Technical Note

Project:	Adamstown Station Phase 3 - Block ACD		
Subject:	Block ACD - Roads and Transport RFI response		
Author:	Peter Foley		
Date:	08/09/2022	Project No.:	5150924
Atkins No.:	5150924DG0112		
Distribution:	SDCC and Design Team

1. Adamstown Station Phase 3 Block ACD

Figure 1: Currently proposed and previously submitted footpath on West Street.

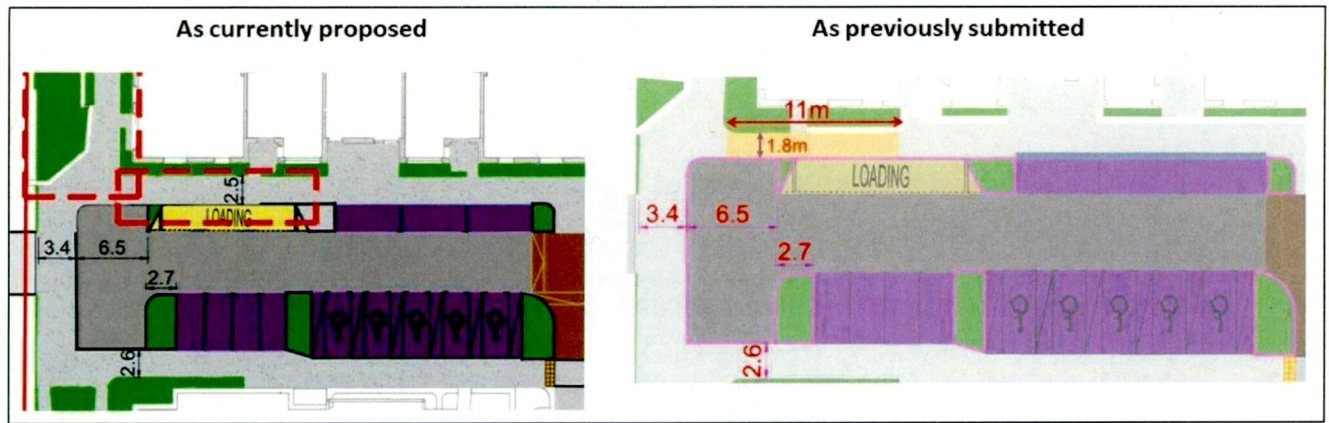
"The applicant is requested to submit a revised layout not less than 1:200 scale showing the minimum width of footpaths at 2.0m wide."

On the previously submitted Block ACD application on a small section of West Street the footpath was reduced to 1.8m to provide defensible space to a ground floor residential unit. This has been revised for the current submission. The previously submitted and currently proposed images are shown in Figure 1 for ease of reference.

Figure 3: Internal changes to undercroft to incorporate improved access to parking

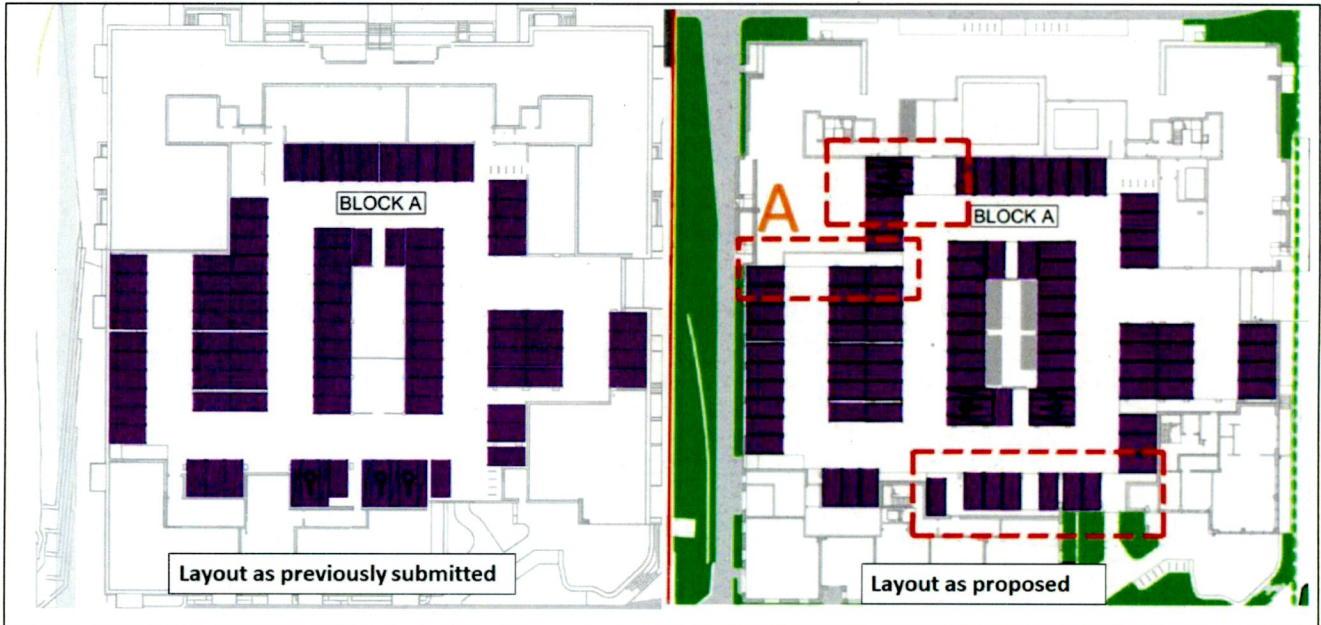
“The applicant is requested to submit a revised layout not less than 1:200 scale showing a turning location at the dead end in the car park of Block A, as per road safety audit.”

The internal layout of the undercroft has been amended as part of the RFI response as shown in Atkins drawing 5150924-HTR-08-DR-0101 Rev C. The changes between the submitted and now proposed are highlighted in Atkins drawing 5150924-HTR-08-SK-0047, an extract of which is shown in Figure 3. This includes a corridor behind the dead-end area (see A on Figure 3) that facilitates additional space to allow cars to manoeuvre into and out of these spaces. Atkins drawing 5150924-HTR-08-SK-046 shows vehicle tracking that shows these end spaces are accessible.

Figure 5: Future West Street crossing locations once access to Boulevard Tile is provided

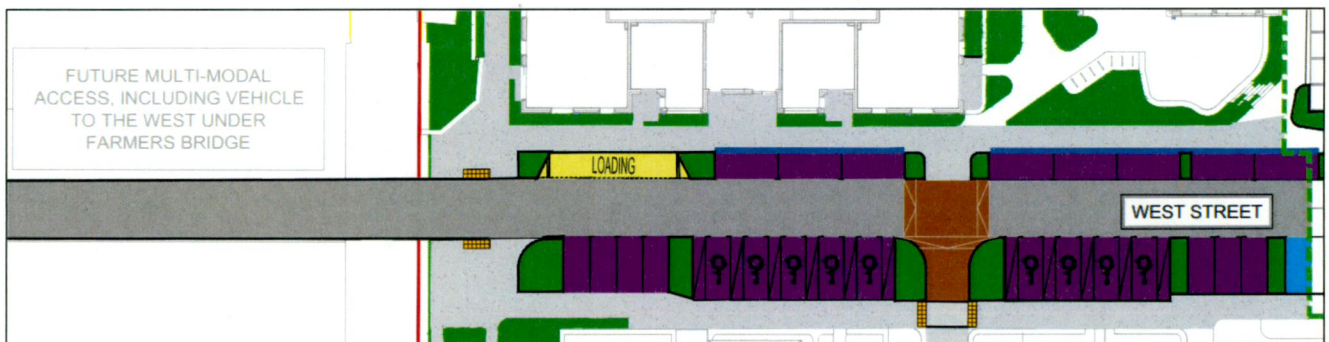
"The applicant is requested to submit a revised layout not less than 1:200 scale showing pedestrian crossing locations along the West Street, as per road safety audit."

West Street is a fairly short street 32metres in length that in the short to medium term will operate as a cul-de-sac with limited traffic likely to require access due to the limited amount of car parking provided along its length. In the longer term the proposal is to provide a through vehicle access under the farmers bridge to connect to Boulevard Tile. Atkins drawing 5150924-HTR-08-SK-044 shows that in this scenario a crossing would be required along the Farmers Bridge. The future scenario is shown in Figure 5.

Figure 6: Visitor set down parking spaces on Station Road.

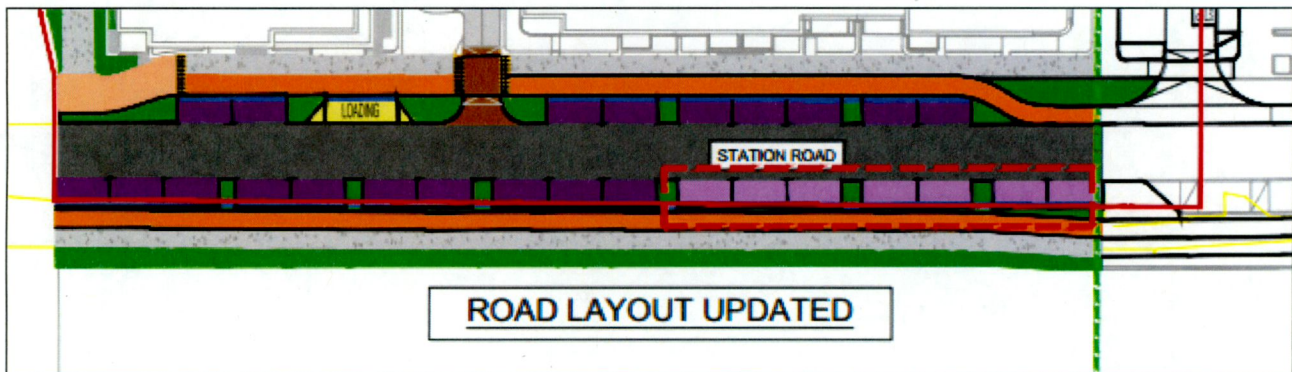
"The applicant is requested to submit a revised layout not less than 1:200 showing 7no. assigned car parking spaces on the south side of the Adamstown station Road as unassigned set-down parking spaces for use at the train station."

Atkins drawing 5150924-HTR-08-DR-0101 Rev C shows revision 7no. car parking spaces on Station Road as set-down parking spaces for use at the train station. An extract is shown in Figure 6.

Figure 7: Overview of cycle infrastructure on Station Tile

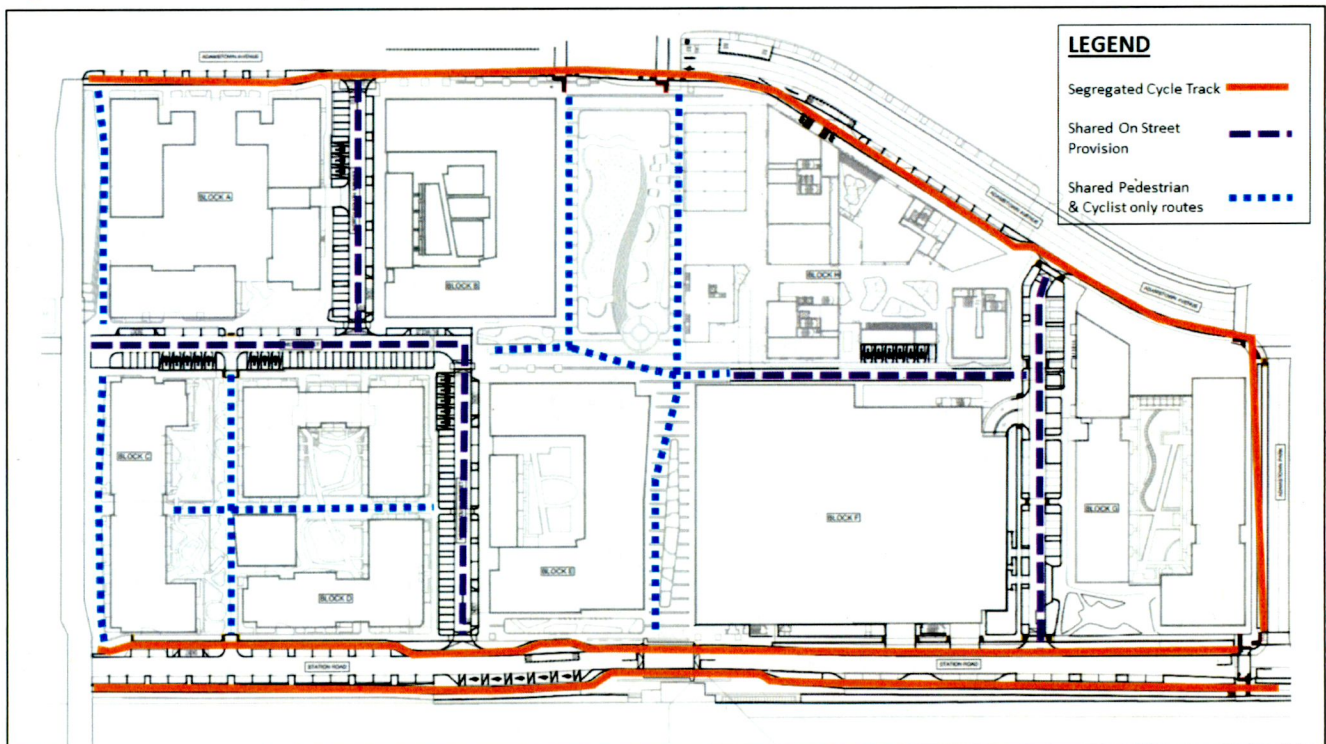
“The applicant is requested to provide details of how the cycle lanes are compliant with the NTA cycle design guide.”

On Avenues within the planning application, (sections of Station Road and Adamstown Avenue), that is higher order functional roads with higher volumes of traffic fully segregated cycle lanes have been provided. The design of these segregated cycle lanes is identical to the previous phase for the Station Tile including the agreed approach along Station Road which was agreed with the National Transport Authority (NTA). While on quieter roads such as West Street the design approach is that cycle facilities are provided in a shared on street provision. In addition to the above there are areas within ACD, such as along Famers Bridge, between block C&D where there is shared pedestrian and cycle routes only. This approach is shown in Figure 7 an extract from the Transport Statement submitted as part of the planning application.

This approach is consistent with National Cycle Manual Section 1.7 Integration and Segregation.

Figure 9: Bus set down and turning areas provided on Station Road on Boulevard Tile

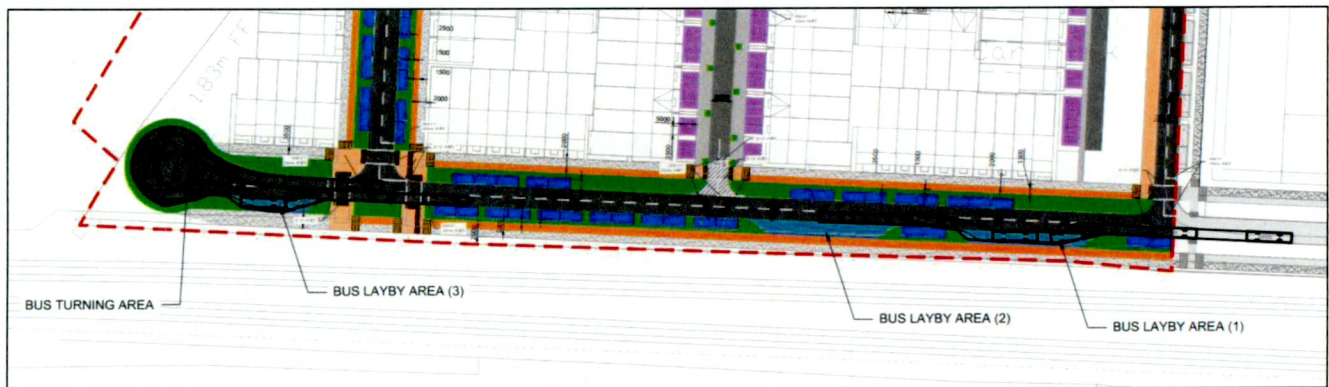
“The applicant is requested to provide details of bus set down areas.”

Bus set down areas and bus turning areas are provided on Station Road on the adjoining Boulevard Tile. Atkins drawing 5150924-HTR-10-DR-0129 submitted as part of the planning application (Ref SDZ22A/0007) for Adamstown Boulevard Phase 1 to South Dublin County Council (SDCC) shows the location of the set down and turning facilities. An extract of this drawing is shown in Figure 9 and a copy of the drawing has been submitted as part of this RFI for information. The 3No. laybys provide capacity for 5 No. buses to set down. This approach was discussed and agreed with SDCC (Roads) and the NTA during formal pre-application discussion for Boulevard Masterplan and Phase1 planning application.
